MIL-S-19500/330A(EL)
AMENDMENT-5

29 January 1974
SUPERSEDING
AMENDMENT-4
15 June 1971

SEMICONDUCTOR DEVICE, TRANSISTOR, PNP, GERMANIUM TYPES 2N1557A through 2N1560A

FIGURE 4. SAFE AREA TEST CIRCUIT

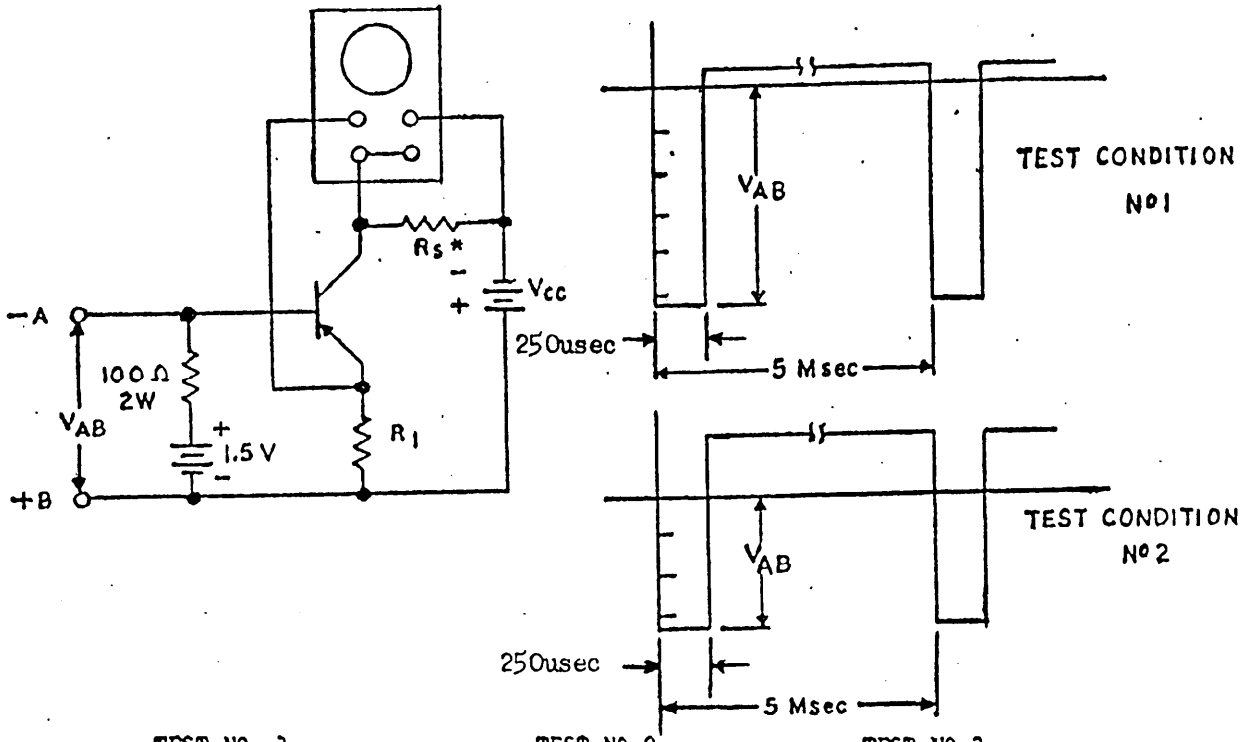
Subgroup 5 of Group B, under conditions, add: "See figure 4".

Add: Figure 4.
